ISSUE: Permit to Demolish/Capsulate (partial) and Certificate of Appropriateness for alterations and addition

APPLICANT: 214 and 216 S Payne LLC

LOCATION: Old and Historic Alexandria District
214 and 216 South Payne Street

BAR #2021-00134 & BAR #2021-00355
214 and 216 South Payne Street

Figure 2: Existing front (west) elevation of existing building

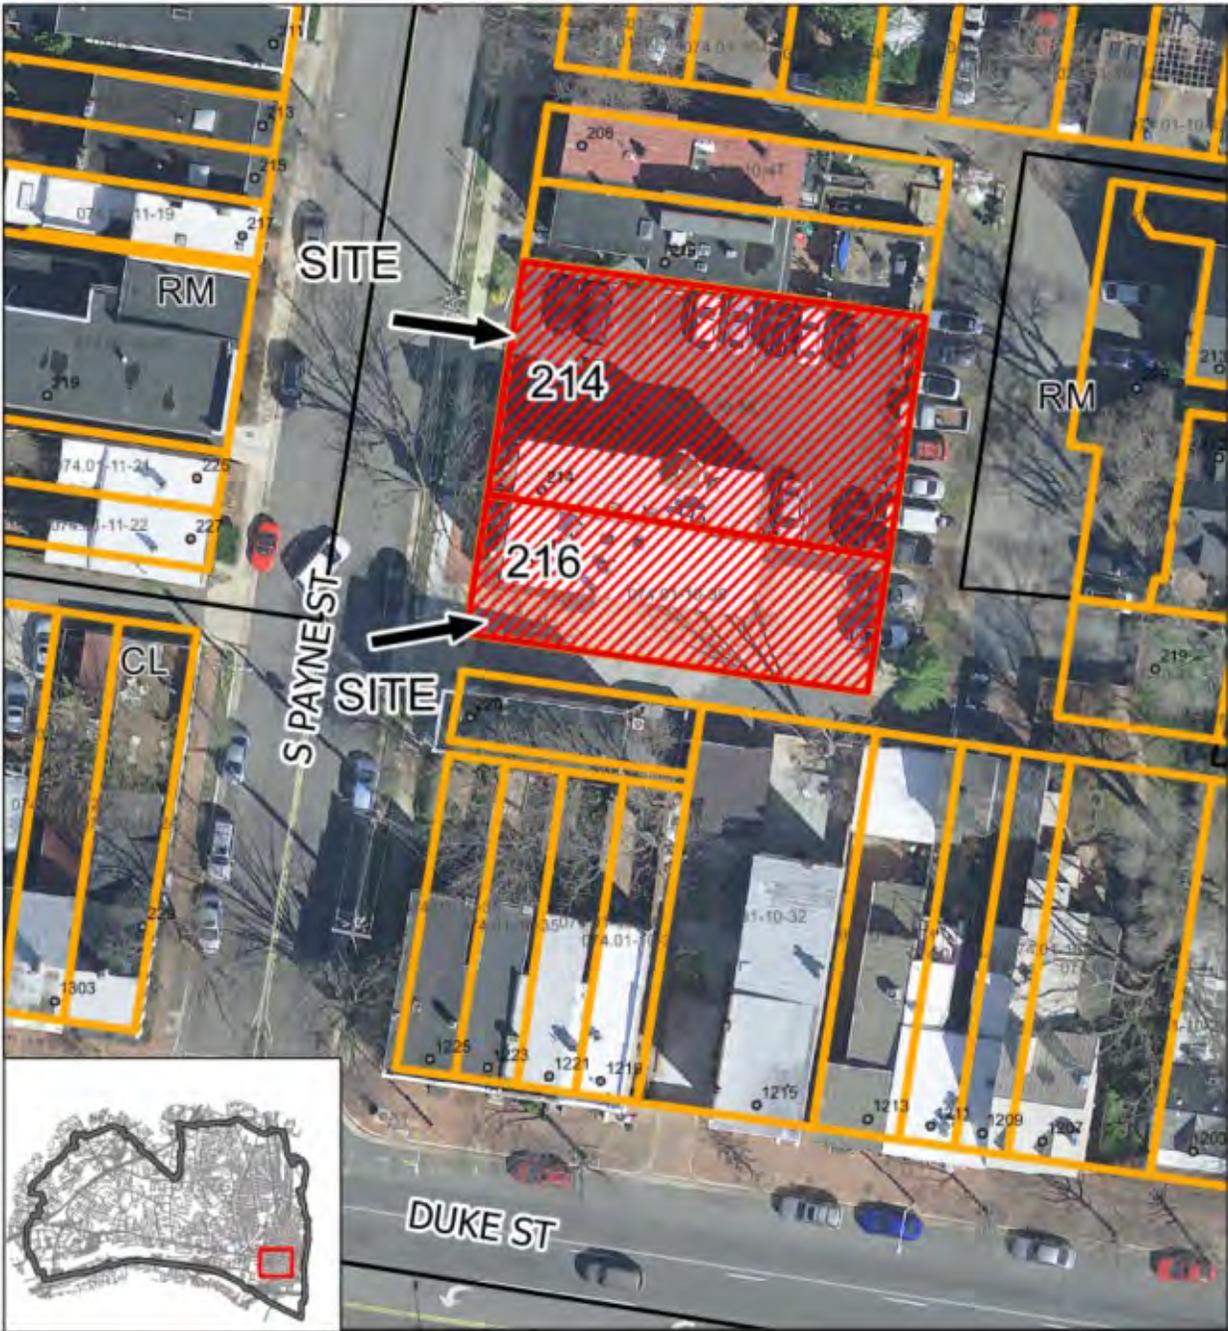
Staff believes that the Demolition/Capsulation at the front elevation of the building would detract from the architectural character of these unique historic structures and would be a detriment to the public interest. The brick buildings were built as twins and feature two faceted towers with a central covered porch between them and a monumental entry stair with stone piers and wood railings. Built to be two separate but attached structures, the front (west) elevation is entirely symmetrical around the party wall with paneled entry doors with rounded transoms and second floor windows centered on each of the entry doors with rounded heads. The tall ground floor windows are a hallmark of the architectural style and feature decorative brick heads and stone sills (Figure 2).

The applicant is proposing to demolish the two central second floor windows and replace them with a single three part window. The duplicate windows in this location, along with the two entry doors, mark this as a set of twin buildings and their replacement with a single window would be counter to the history of the structure. The applicant is also proposing to remove the monumental stairs and decorative roof between the two tower elements. These are unique architectural elements and correspond to the strong vertical towers at the corners of the building. Staff feels that the removal of the historic fabric on the front (west) elevation would be counter to preservation principles and would be a detriment to the greater public interest. Staff recommends denial for the Permit to Demolish/Capsulate for the work at the front (west) elevation.

Figure 3: Proposed front (west) elevation

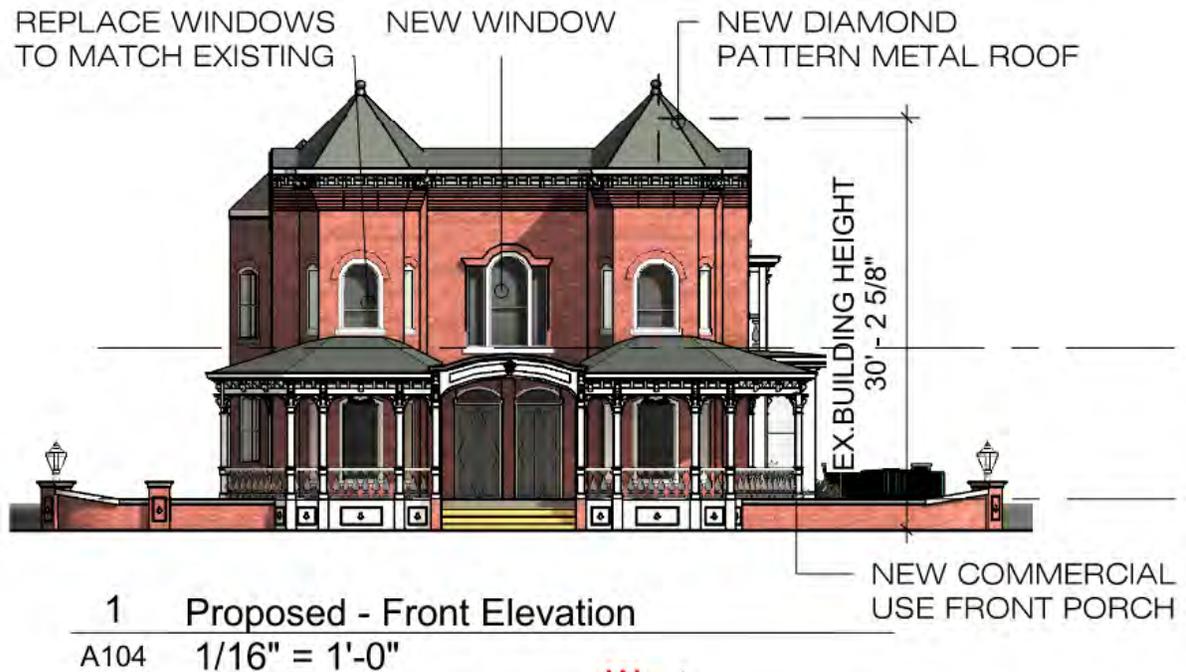
As noted above, the applicant is proposing to install a new single, three-part window in place of the existing two windows centered above the two main entry doors. They are also proposing to replace the existing covered front porch that fits between the two tower elements with an enlarged raised porch covering the entire front of the building and projecting approximately 6'-9" from the front of the existing porch. Two new curved site walls will extend from the north and south edges of the porch to enclose the front of the side yards (Figure 3).

The *Design Guidelines* say that “An addition should not obscure or dilute the architectural and historic importance of an existing building by creating a false sense of the past.” Section 10-105(A)(2)(b) of the Zoning Ordinance says that one of the criteria to be reviewed in approving a Certificate of Appropriateness is “the degree to which the distinguishing original qualities or character of a building, structure or site (including historic materials) are retained;”.

The proposed porch addition, site walls, and modifications to the front (west) elevation of the existing building will significantly modify the architectural character of this pair of unique historic buildings. The replacement of the pair of windows on the second floor with a single three-part window will give the appearance of this being a single building instead of the mirrored pair as it was originally designed and built. This will be contradictory to the double entry doors below and not in keeping with the history of the building. The proposed porch addition changes the proportions of the building, currently the twin tower elements create a strong vertical proportion to the building consistent with this architectural style. The porch will obscure the base of these towers and give the building elevation a horizontal orientation. These modifications will compromise the character and historic materials of the existing building, contrary to the directions of the cited Zoning Ordinance criteria, Staff does not support the approval of the Certificate of Appropriateness for the work proposed on this elevation.

Staff recommends denial of the Permit to Demolish/Capsulate (partial) and the Certificate of Appropriateness for work on the front (west) portion of the building and project site. This includes the following work:

Figure 4: Proposed south elevation

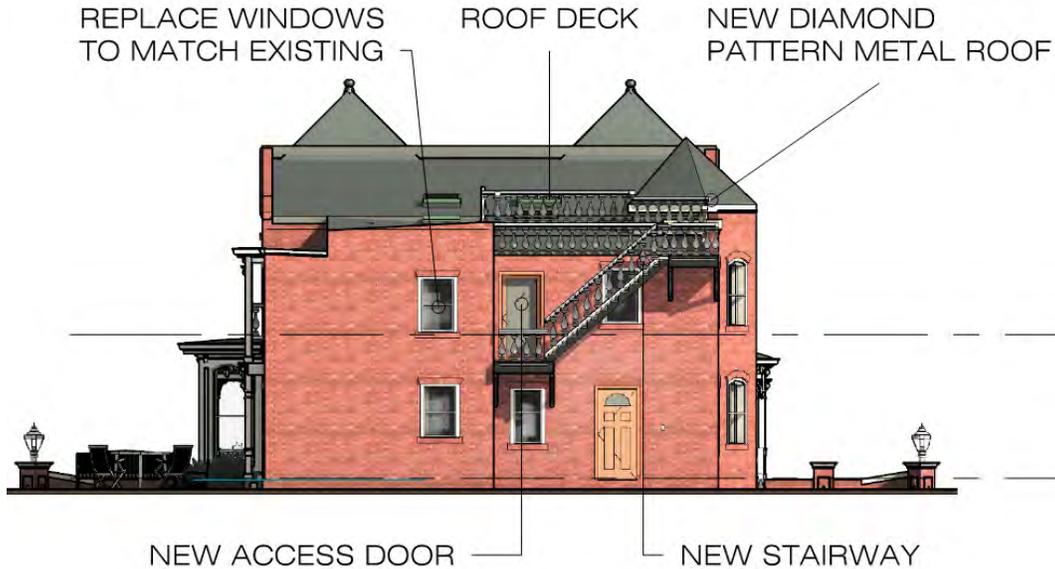
In the current configuration, the existing building features a notch in the masonry footprint in the rear half of the south elevation that is infilled with a decorative wood porch and exterior stair to provide access to the upper levels from the side yard. The applicant is proposing to remove the existing porch and stair and replace it with a new one of similar design but protruding from the face of the building by approximately 1'-6" in order to allow enough room on each level of the porch for it to be occupied. The applicant is also proposing to reduce the overall length of the

notch by approximately 3'-6" by increasing the masonry footprint on the north end to allow for a shower on the interior (Figure 4). The brick on the side of the building is painted so there will not be an issue of matching the existing brick in color and size.

As noted above, the Zoning Ordinance is concerned with maintaining the historic character of a building. While the existing side porch being bound by the adjacent masonry piers is reminiscent of the front porch between the brick tower elements, this is occurring on a secondary elevation and the architectural language remains the same. Since the brick is painted, the proposed masonry addition at the north end of the notch will be indistinguishable from the existing masonry. Staff finds that the proposed modifications to the south elevation do not significantly change the character of the building or remove important or unique historic fabric and supports the approval of the Certificate of Appropriateness for the work on this elevation.
